Re: Northern California Power Agency Lodi Energy Center (08-AFC-10C)
Petition to Amend Air Quality Conditions of Certification

**Petition to Amend
Air Quality Conditions of
Certification for the
Lodi Energy Center Project
(08-AFC-10C)**

Re: Application for Permit Modification
Northern California Power Agency, Lodi Energy Center
Permit No. N-2697-5-0

CO Emissions During Gas Turbine Startups NCPA Lodi Energy Center

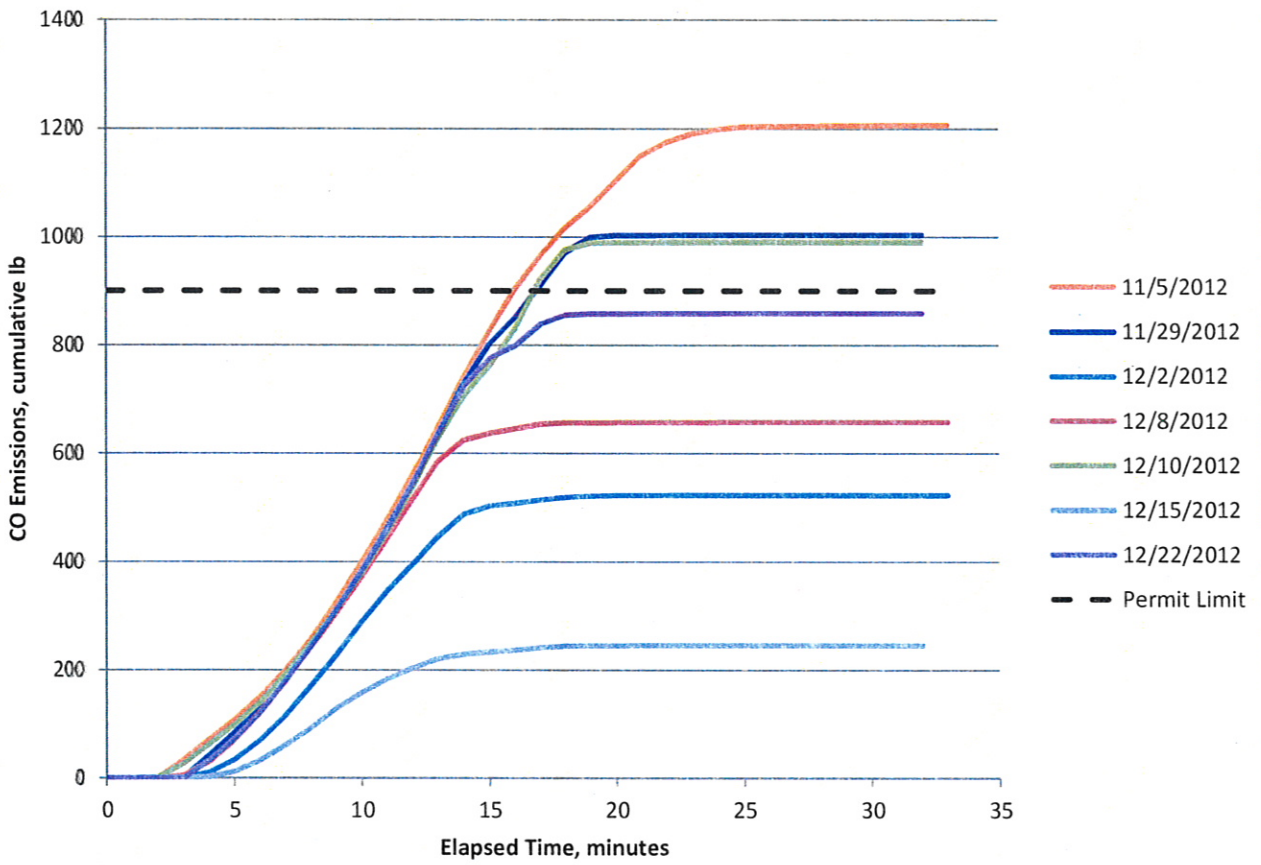
The attached figure shows how CO emissions from the turbine vary during startups. The highest hourly CO emission rate observed during any gas turbine startup to date is 1,207 pounds per hour. Based on this, we are requesting an increase in the maximum hourly CO emissions limit during startup to 1,500 pounds per hour, to provide a 25% compliance margin above the maximum observed emission rate.
